1988 - 1989 Corvette: Recall Notice: Rear Wheel Tie Rod

Bulletin No: 89C17

Subject: PRODUCT SAFETY CAMPAIGN 89C17
REAR WHEEL TIE ROD

Model and Year: 1988-89 CHEVROLET CORVETTE

FIGURE 1

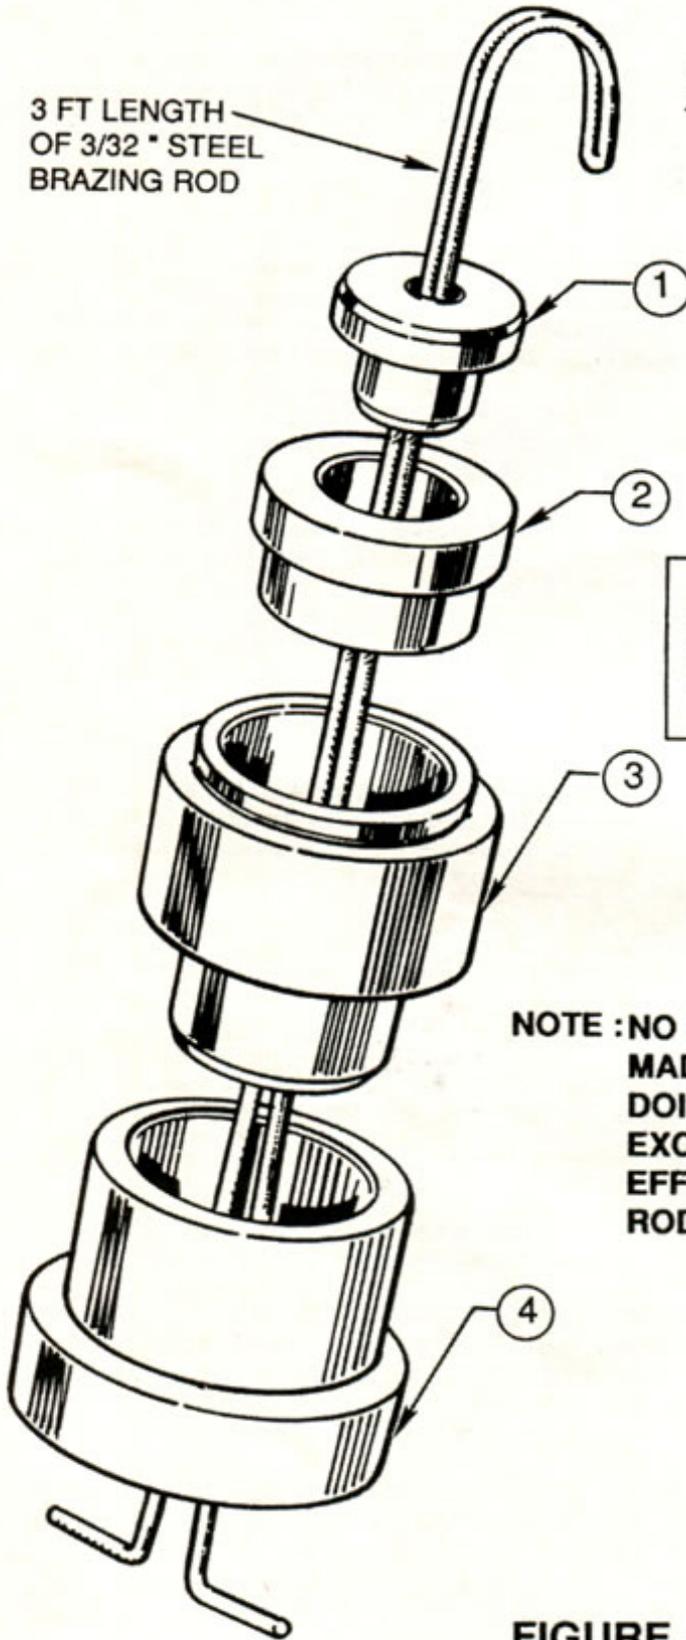
1. Fabricate/Assemble weight from materials indicated and as illustrated in Figure 1.
2. Raise Vehicle.
3. Remove cotter pins, nuts and washers from both outer rear tie rod ends and disconnect from knuckle assemblies utilizing tool J-24319-01.

3 FT LENGTH
OF 3/32 " STEEL
BRAZING ROD

- ① J - 24895
- ② J - 9398 - A
- ③ J - 9481 - A
- ④ J - 26271 - A

ABOVE TOOLS ARE PART OF GM 4
CYLINDER (R - 4) COMPRESSOR TOOL
KIT J - 29892 -A

**NOTE : NO SUBSTITUTIONS SHOULD BE
MADE FOR THE TOOLS INDICATED.
DOING SO, MAY RESULT IN AN
EXCESSIVE WEIGHT WHICH COULD
EFFECT THE ACCURACY OF TIE
ROD INSPECTION.**

FIGURE 2

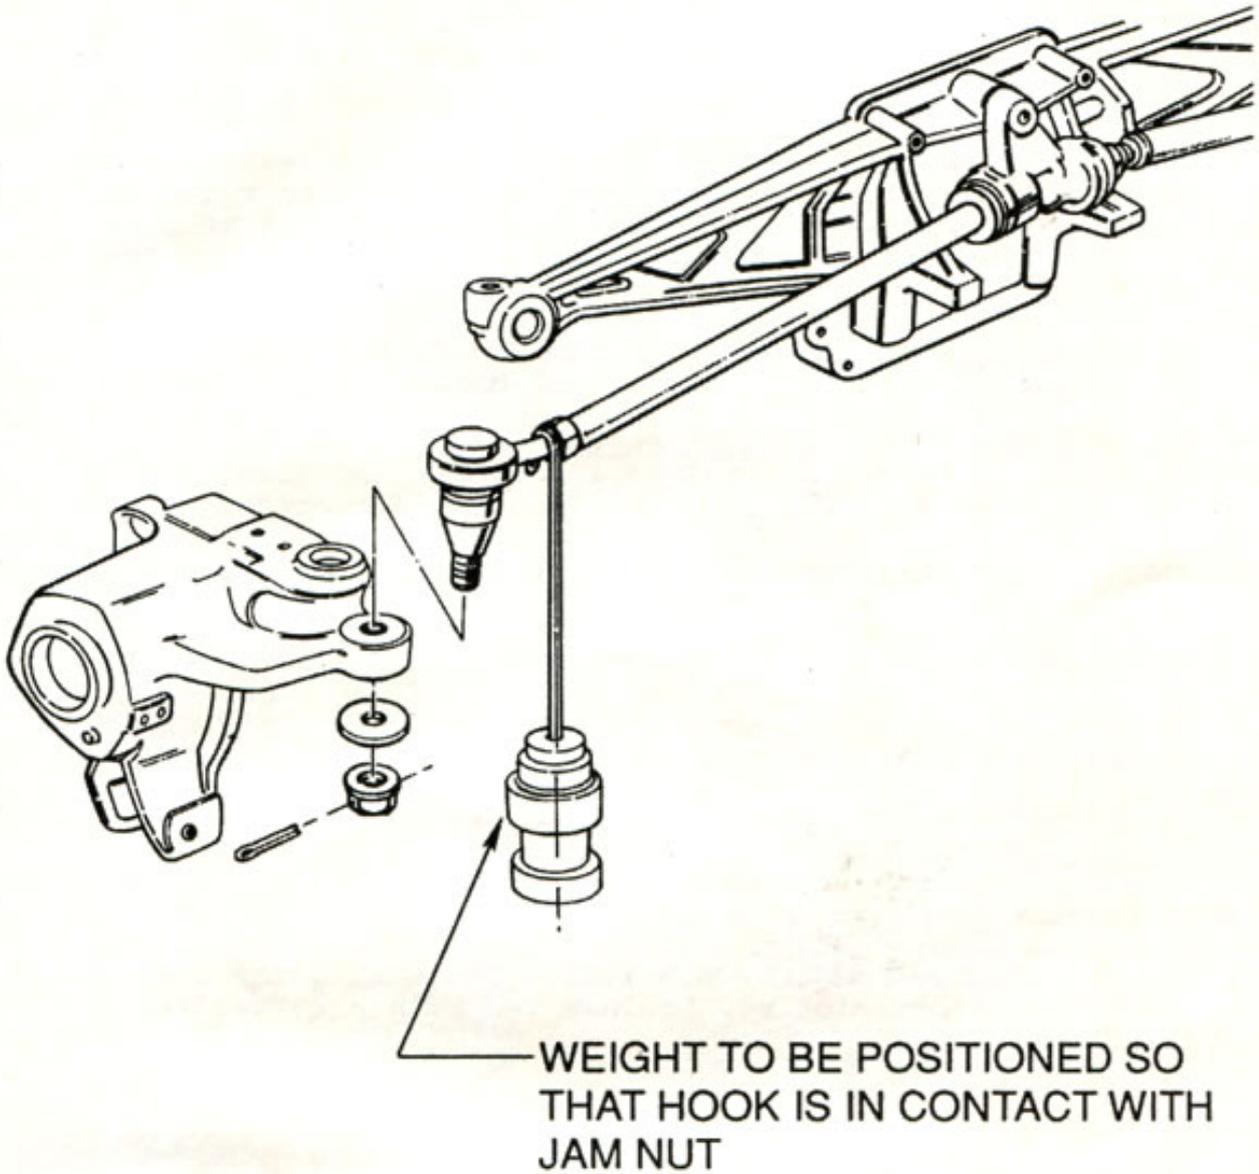
4. Raise and hold outer end of left hand tie rod linkage in its upper most position, insuring rod is not rotated while being raised. Attach weight as shown in Figure 2, release linkage and note results. Repeat procedure on right hand tie rod linkage.
5. Based on observations noted in performing step 4, select appropriate action from those noted below:
 - A. Linkage moves downward on both sides - Reconnect tie rod sockets to knuckles, install washers and nuts, torque nuts to 45 Nm (33 lbs. ft.) and install cotter pins.
 - B. Linkage on either or both sides doesn't move downward - Replace tie rod assembly, transferring existing tie rod ends to new assembly and following Section 3D in the Chevrolet Corvette Service Manual of the appropriate year.
6. Install Campaign Identification Label.
